Date Issued :	November 08, 2022	PCN Number :	512754
Reason for Change :	Change Supplier		
Description of Change :	This notification is to inform you about change of supplier impacting the part(s) attached as per list, No changes will be made to product as part of this change.		
Reason for Short Notice :	Special Request		
Assessment of Change :	Supplier Qualification Test Report/s		
Planned Implementation Date :	February 19, 2023		
Sample Availability Date:	January 20, 2023		
Internal Molex Qualification Date :	February 01, 2023		
Last date to request Samples by Customer :	January 31, 2023		
Traceability Code Markings / Date :	Date code

Overview

P/N#
1051620001

Before Picture

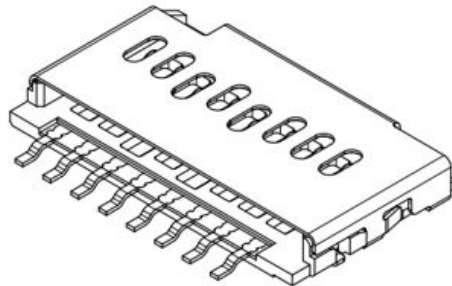
- series Add alternative copper material " C5210-SH".
Before change: "C5240-EH"
After change: "C5240-EH" or "C5210-SH"

1. MATERIAL: PHOSPHOR BRONZE HYPER C5240-EH.
THICKNESS: 0.12mm.

- 1.Material:
 - a.Phosphor bronze hyper C5240-EH ,T=0.12mm.
 - b.Phosphor bronze C5210-SH, T=0.12mm.
